**TOWNSHIP OF NORTH DUMFRIES  
BUILDING DEPARTMENT**

These Plans have been examined for compliance with the Ontario Building Code requirements. A Building Permit has been issued, subject to any changes noted, under the condition that the building will be constructed in accordance with the code.

Tice River Homes  
Legacy

client: Tice River Homes  
location: Ayr  
project: Legacy  
marketing name:  
model: SD-01  
scale: 3/16" = 1'0"  
project #: 17052

A8

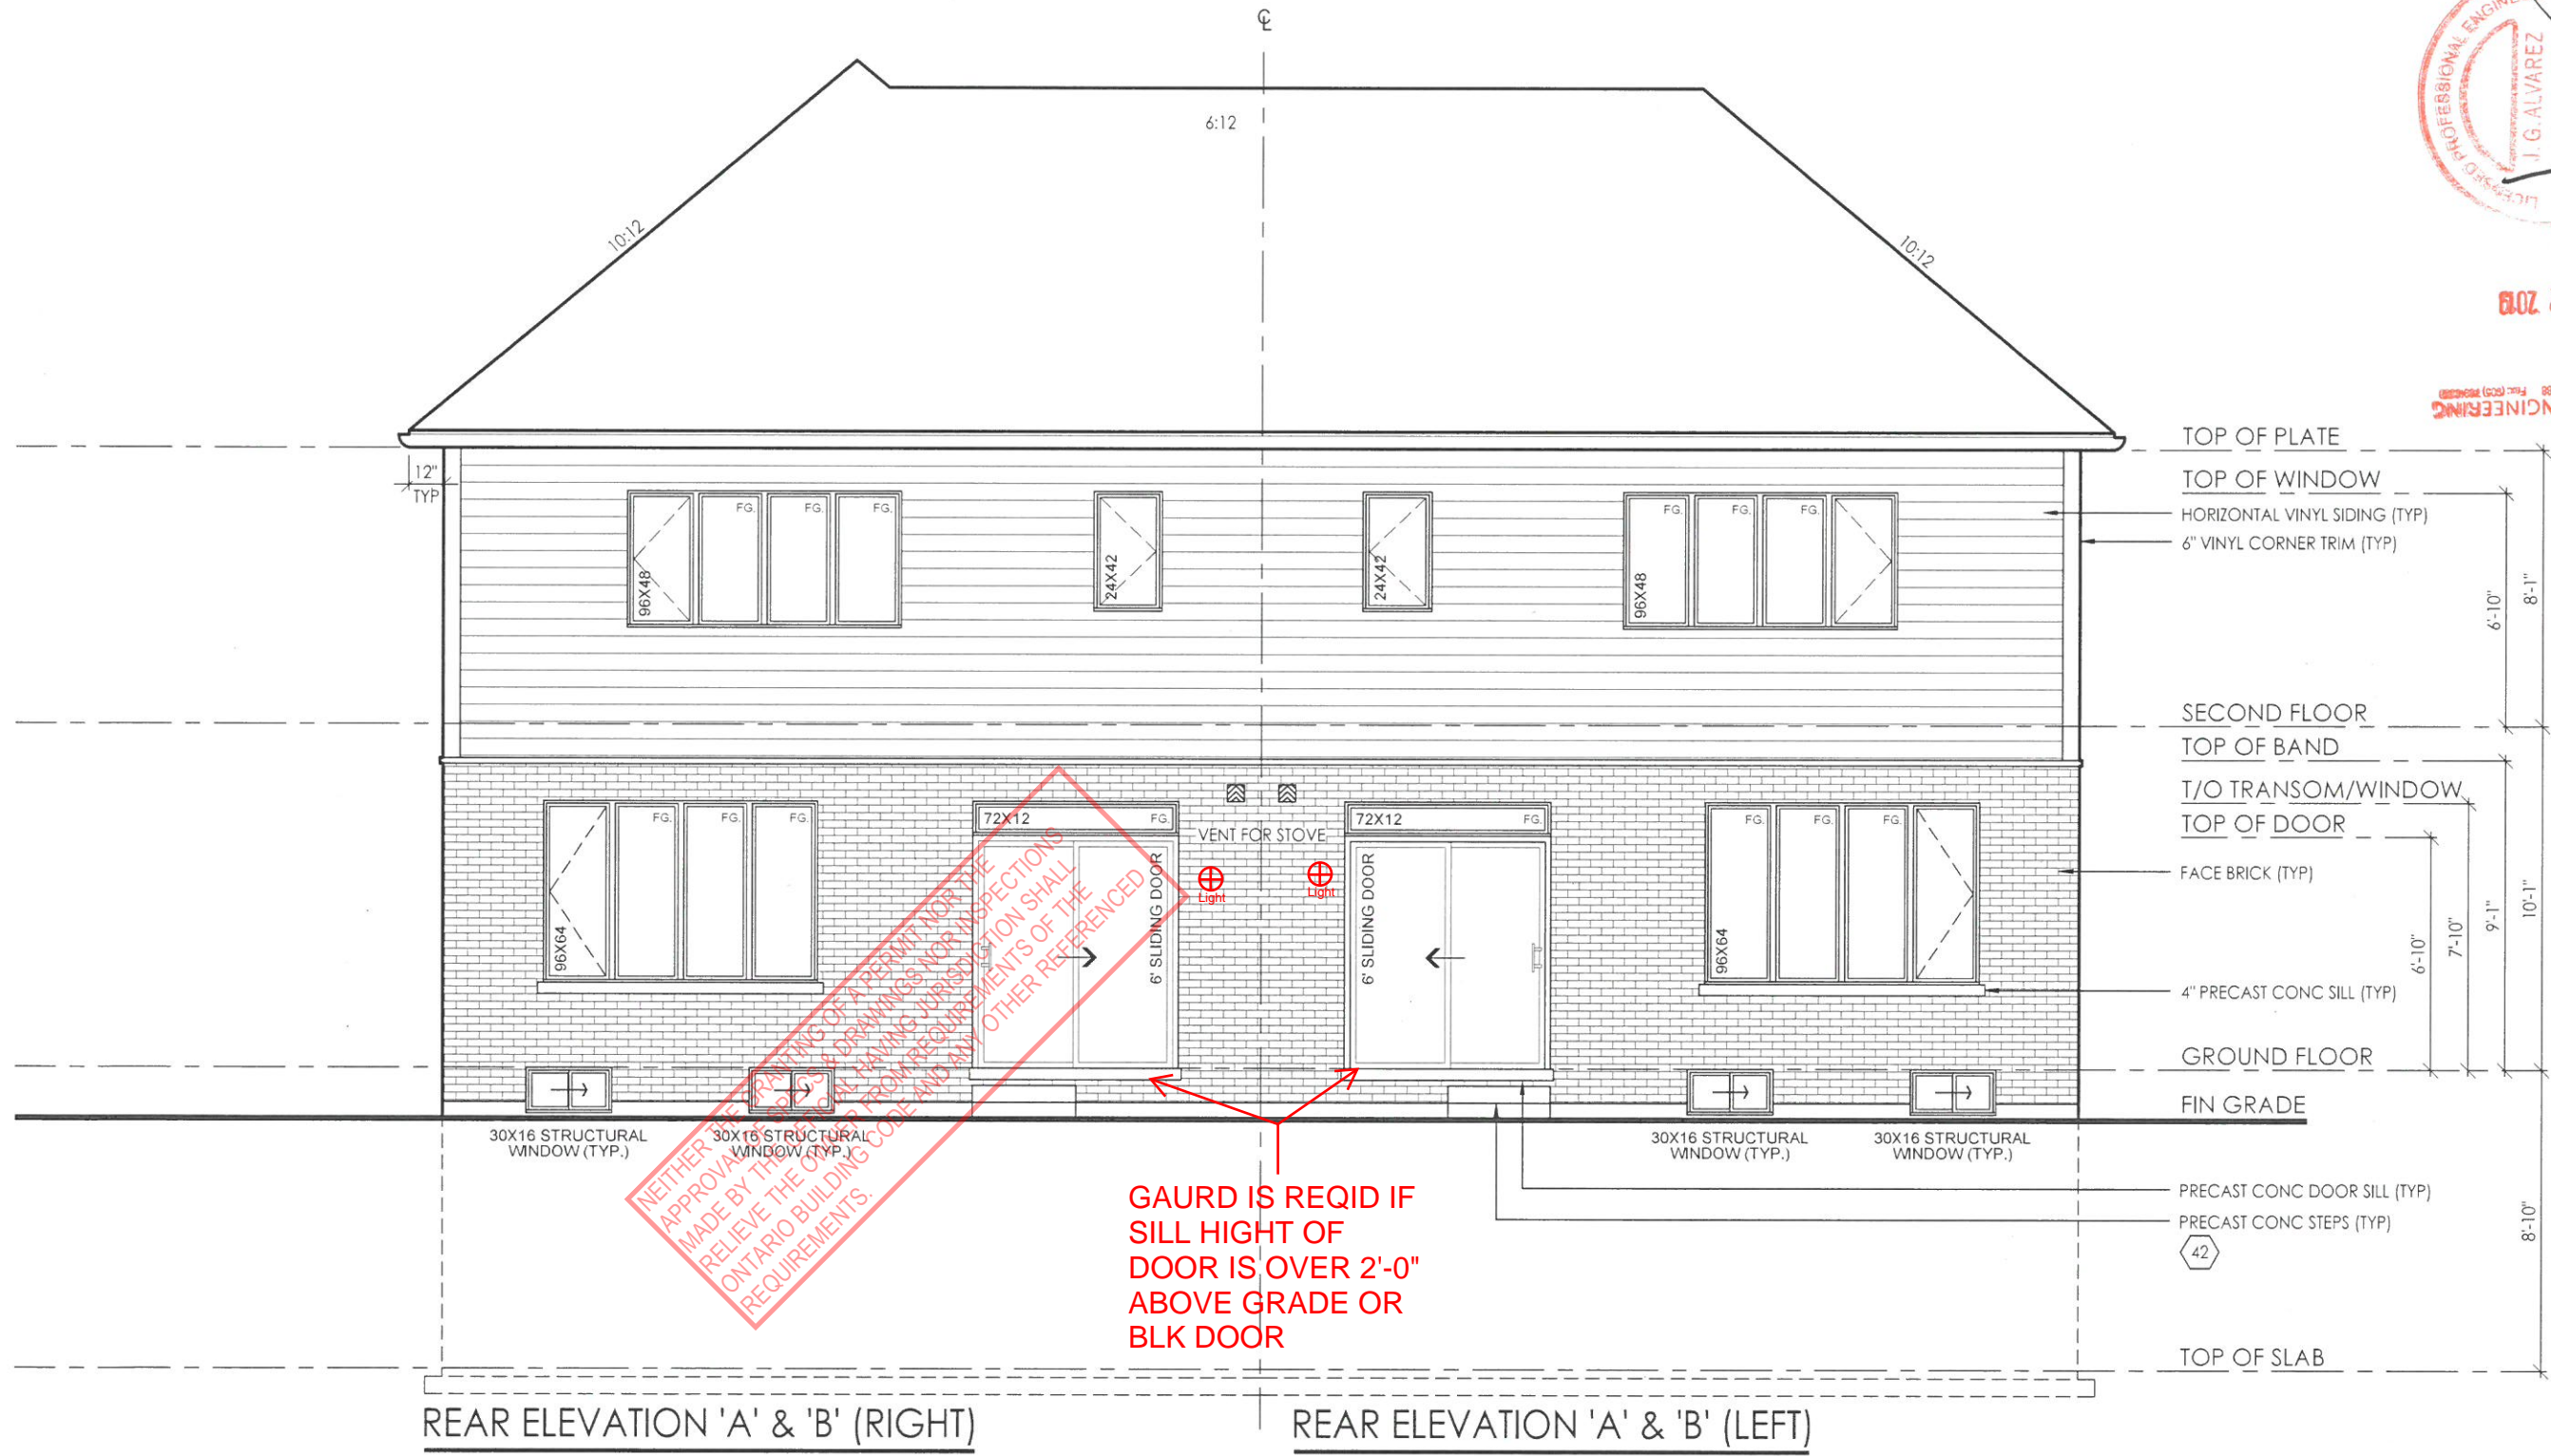
GAURD IS REQID IF SILL HIGHT OF DOOR IS OVER 2'-0" ABOVE GRADE OR BLK DOOR
